June 27, 2025

**Re: Chapter 105 Joint Permit Applications – Response to Technical Deficiency Notification
Tioga Pathway Project
DEP Application No. E5983220-013 (Tioga Co.), APS ID No. 1125745; AUTH ID No. 1506547
DEP Application No. E5383224-006 (Potter Co.), APS ID No. 1125735; AUTH ID No. 1506536
Tioga and Potter Counties, Pennsylvania**

On May 2, 2025, National Fuel and Tetra Tech, Inc. (“Tetra Tech”) – National Fuel’s environmental consultant – received a Technical Deficiency Notification from the PADEP. The following information is provided in response to the PADEP’s technical comments and all the supporting documents (i.e., revised attachments/files, etc.) have been electronically uploaded to the appropriate RPCO project Public Upload site for each of the Tioga Pathway Project’s Individual Permit Applications (i.e., Tioga County and Potter County), as identified in the responses below.

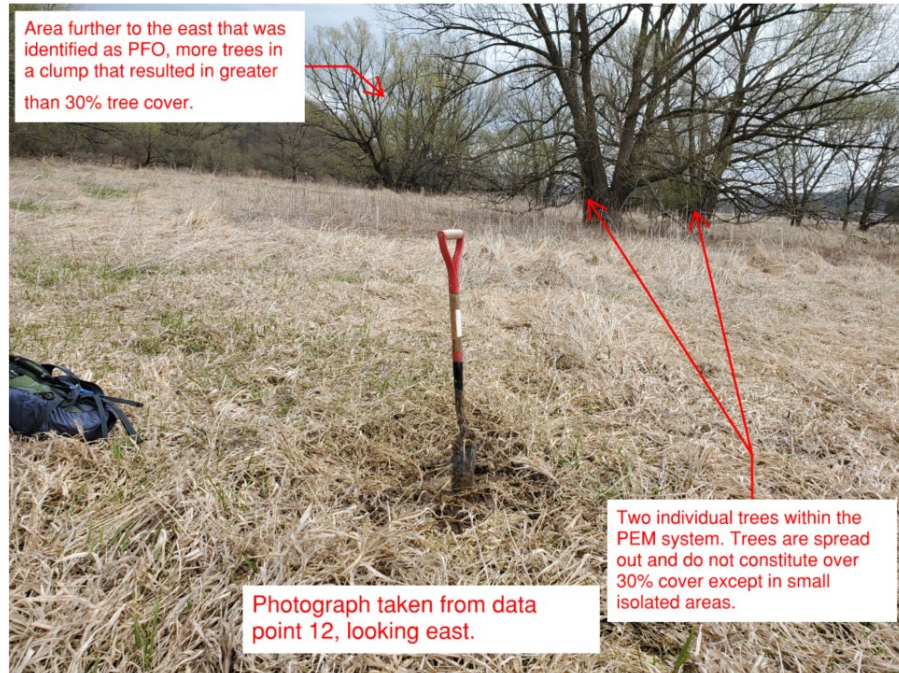
37. *From the aerial images in the PRM Plan it appears that existing PEM and PFO habitat may be overestimated and underestimated, respectively. Please address. [25 Pa. Code § 105.21(a)(1) and 105.20a(b)]*

Response: While aerial imagery can be useful for an informal site examination, determining the Cowardin classification includes factors (plant cover, type, soil composition, etc.) that can only be ascertained on site during the field delineation. The RES ecologists who performed the wetland delineation were consulted and indicated that the dominant cover type within the area identified as PEM are herbaceous, except for two individual trees. The wetlands in this location do not function as forested wetlands identified elsewhere on-site. An annotated photograph has been included below to further support the findings.
